METROPOLITAN GOVERNMENT OF NASHVILLE AND DAVIDSON COUNTY

STAFF RECOMMENDATION
1602 Lillian Street
March 18, 2015

Application: Demolition; New construction—infill
District: Lockeland Springs-East End Neighborhood Conservation Zoning Overlay
Council District: 06
Map and Parcel Number: 08313045500
Applicant: Lynn Taylor, Taylor Made Homes
Project Lead: Melissa Baldock, melissa.baldock@nashville.gov

Description of Project: Application is to demolish an existing non-contributing structure and to construct infill.

FRONT ELEVATION

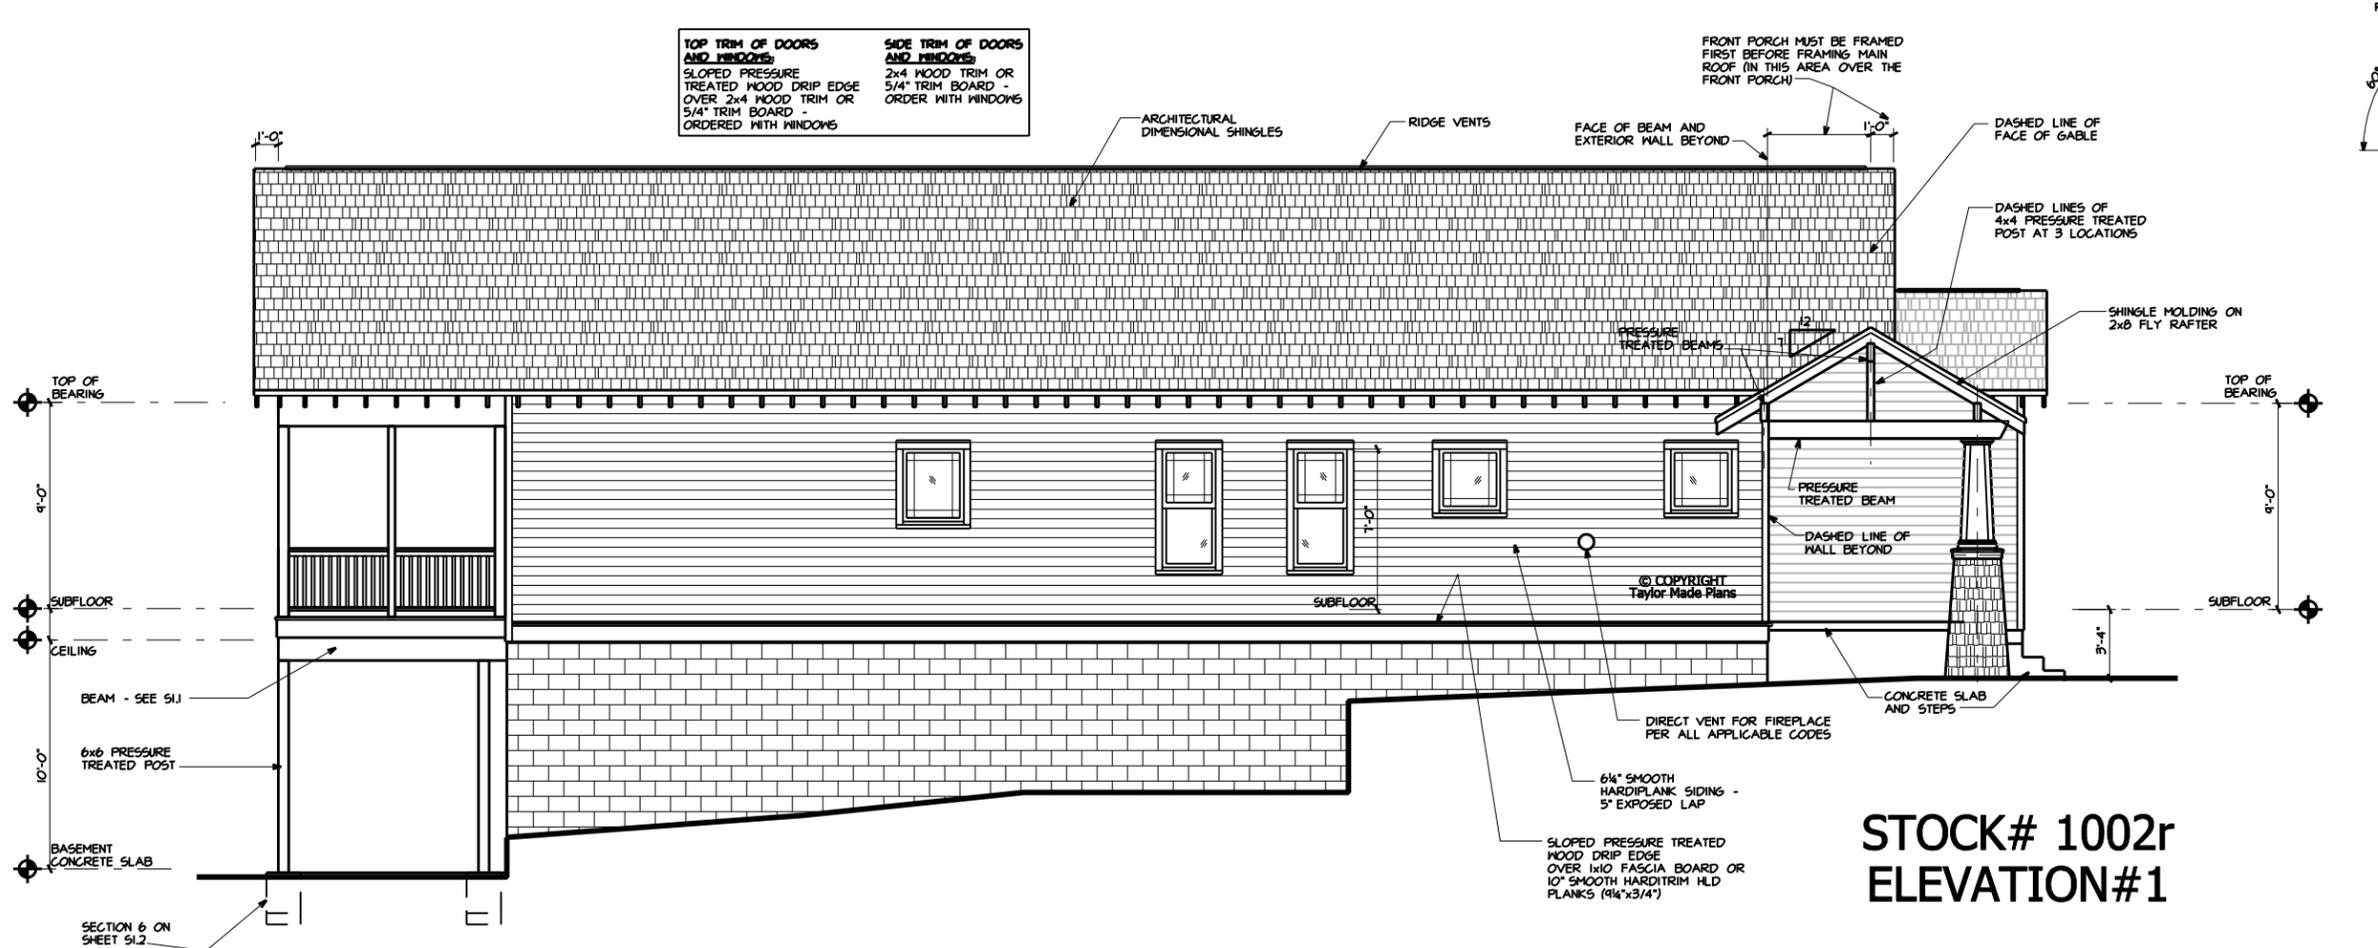
Height, Scale. The infill is proposed to be one-story with a ridge height of approximately twenty-two feet (22’) above grade at the front of the house. This matches the historic context, where historic houses are generally one to one-and-a-half stories and range in height from eighteen to thirty feet (18’-30’). The infill’s main eave height will be approximately eleven feet, six inches (11’6”) above grade, and its porch eave height will be approximately eleven feet (11’) above grade. The foundation is drawn as three blocks high, or approximately two feet (2’) tall, and staff asks to review the height of the foundation and finished first floor system during construction to ensure that the heights are consistent with the neighboring historic houses.

Materials: The primary cladding material will be five inch (5") smooth cement fiberboard lap siding. The foundation will be split face concrete block, and the roof will be architectural dimensional shingles. Staff asks to approve the shingle color. The gable fields and the porch bases will be clad in Hardie shingle. The trim will be wood or cement fiberboard. The porch steps and floor will be concrete. The materials of the windows and doors were not specified, and staff asks to approve the window and door specifications prior to purchase and installation. With the aforementioned staff approvals, staff finds that the infill's materials meet Section II.B.4. of the design guidelines.

Roof Shape: The roof will be a front-facing gable with a 7/12. The projecting gabled bay will also have a 7/12 pitch. The porch roof will be a side gable, also with a 7/12 pitch. The infill design does not include any dormers. Staff finds that the infill's roof forms meet Section II.B.5. of the design guidelines.

1. The finished floor height be consistent with the finished floor heights of the adjacent historic houses, to be verified by MHZC staff in the field;
2. A walkway be added from Lillian Street to the front porch steps;
3. Staff approve the final details, dimensions and materials of windows and doors prior to purchase and installation;
4. The HVAC be located behind the house or on either side, beyond the mid-point of the house; and
5. Staff approve the roof color, dimensions and texture.

LEFT SIDE ELEVATION

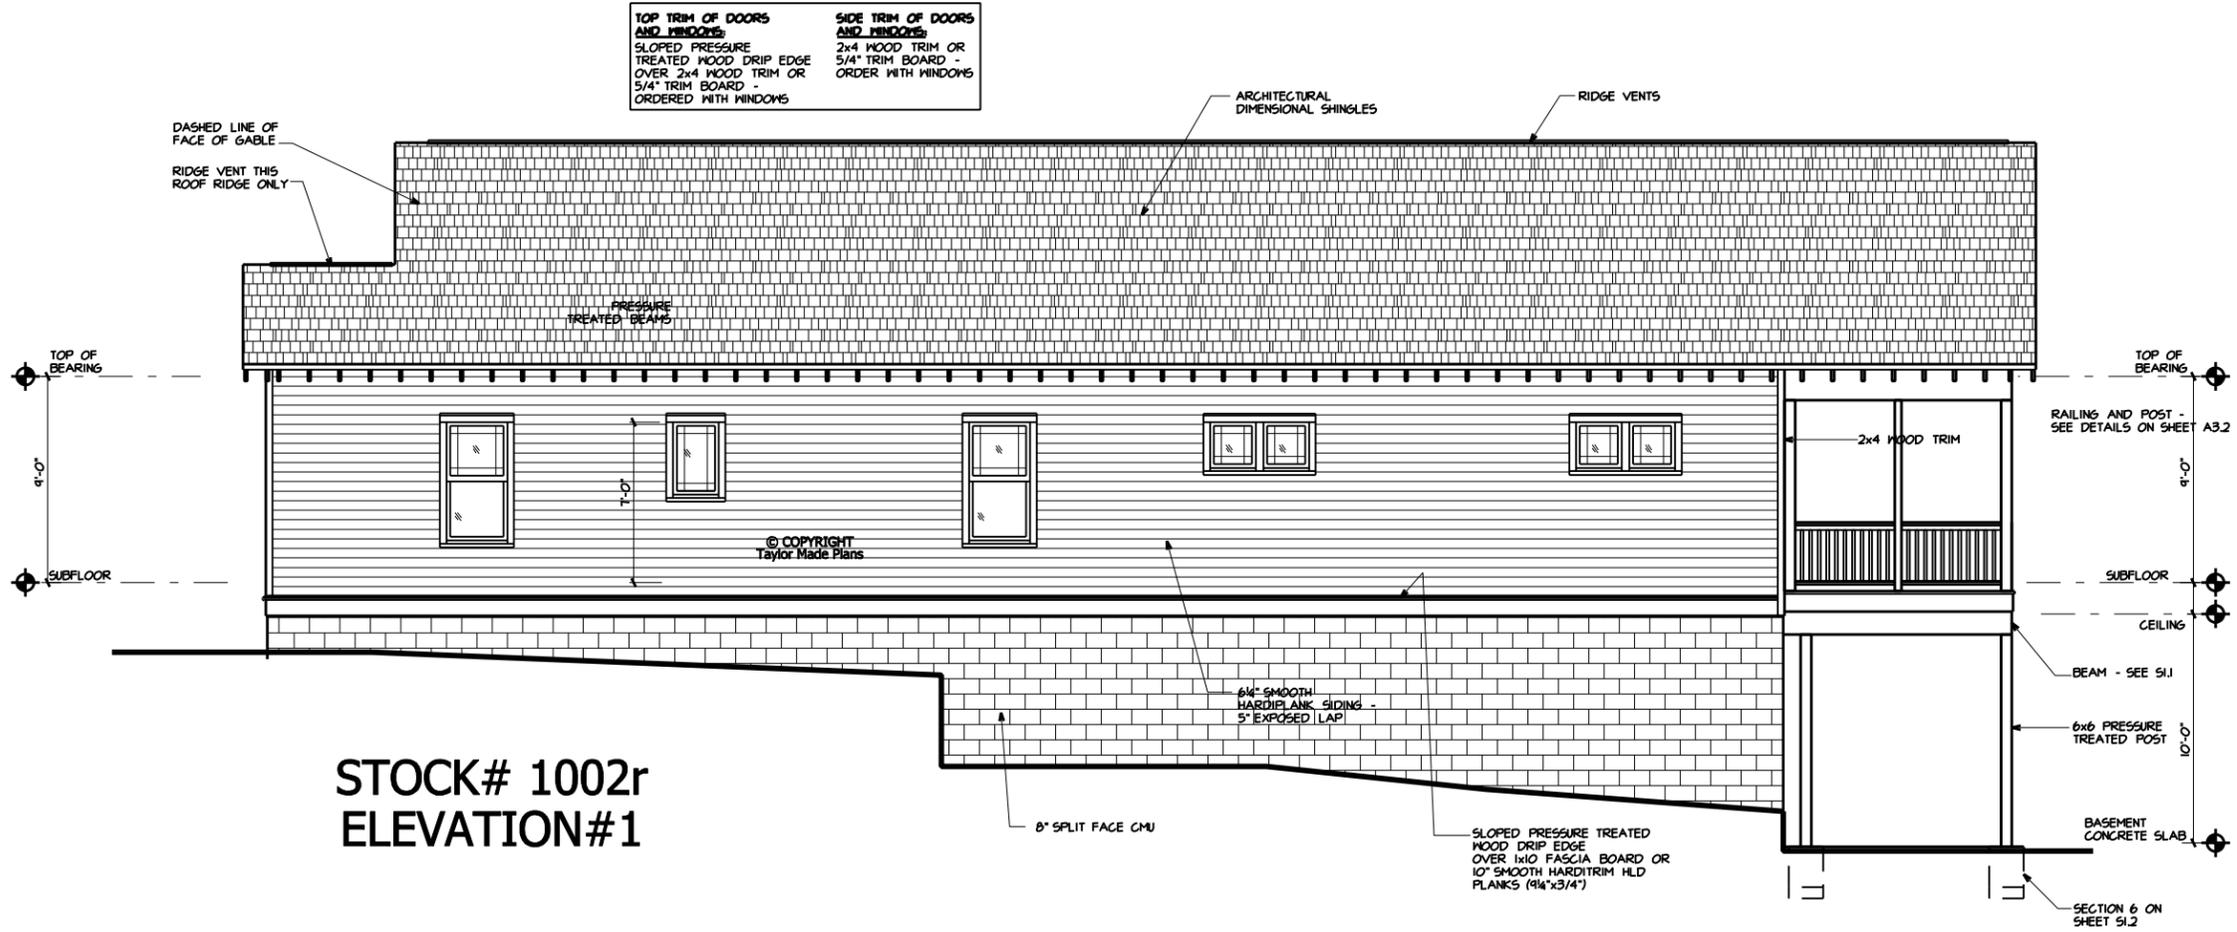
Rhythm and Proportion of Openings: The house's primary windows are twice as tall as they are wide, thereby meeting the historic proportion of window openings. On the left/east façade, there is an expanse of over sixteen feet (16') without a window or door opening. Staff finds this expanse to be acceptable in this instance because it will be located at the back of the house, where it will be only minimally visible from the street. Staff finds that the infill's proportion and rhythm of openings meet Section II.B.7. of the design guidelines.
